Register Reference : 91A/0751

DEVELOPMENT : Demolition and replacement of existing bungalow and  
septic tank on same site.

LOCATION : Tallaght Road near Wellington Lane, Templeogue

APPLICANT : C.A.G. Construction

1:500 SITE PLAN.

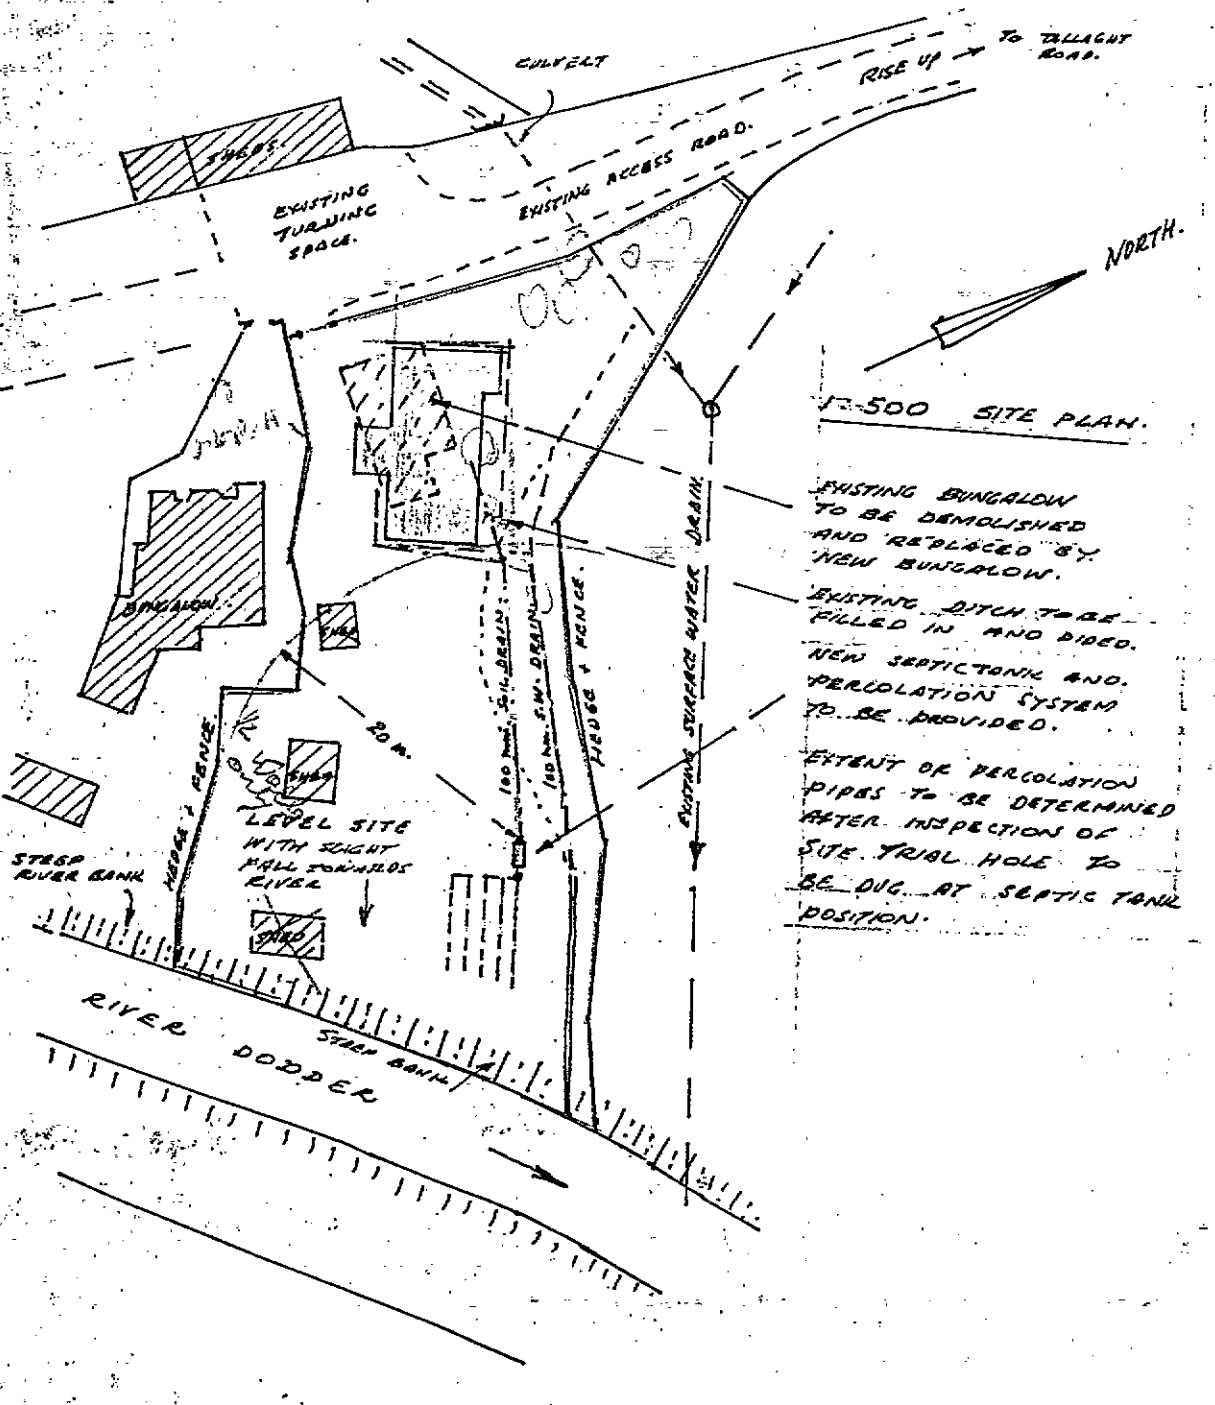
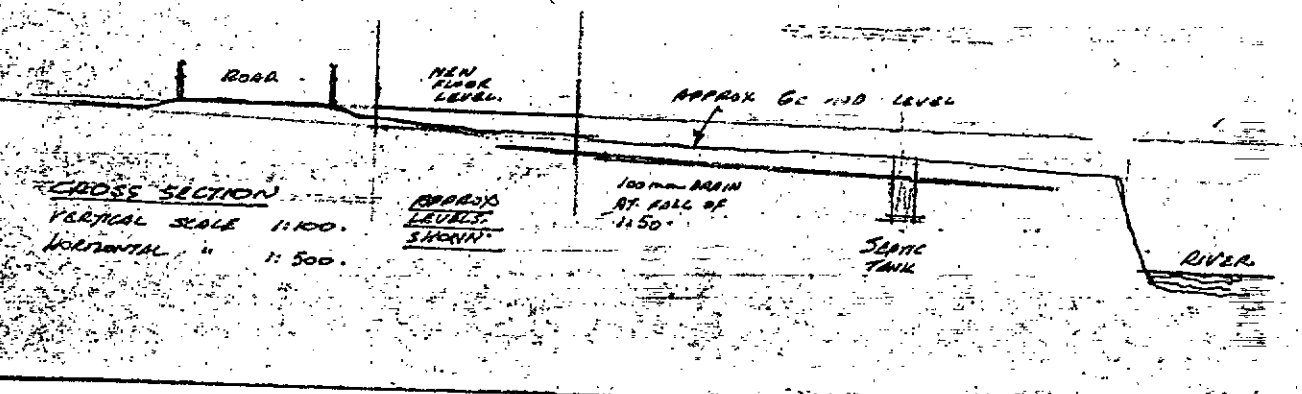
1. The applicant is requested to submit evidence demonstrating that the location and design of the proposed septic tank, percolation and reserve percolation areas are in accordance with the recommendations set out in SR6 1975 available from Eolas. The location of the percolation area and reserve percolation on the adjoining site should be shown in detail.
2. The applicant is requested to submit evidence showing the suitability of the site for septic tank drainage. In this regard he should contact the Supervising Environmental Health Officer (33 Gardiner Street Place, Tel No. 727777) with regard to the opening and testing of a trial hole.

NOTE: The applicants response to these matters received by the Planning Authority on 18th July, 1991, is considered inadequate.

- EXISTING BUNGALOW TO BE DEMOLISHED AND REPLACED BY NEW BUNGALOW.
- EXISTING DITCH TO BE FILLED IN AND DIBED.
- NEW SEPTIC TANK AND PERCOLATION SYSTEM TO BE PROVIDED.
- EXTENT OF PERCOLATION PIPES TO BE DETERMINED AFTER INSPECTION OF SITE. TRIAL HOLE TO BE DIG. AT SEPTIC TANK POSITION.
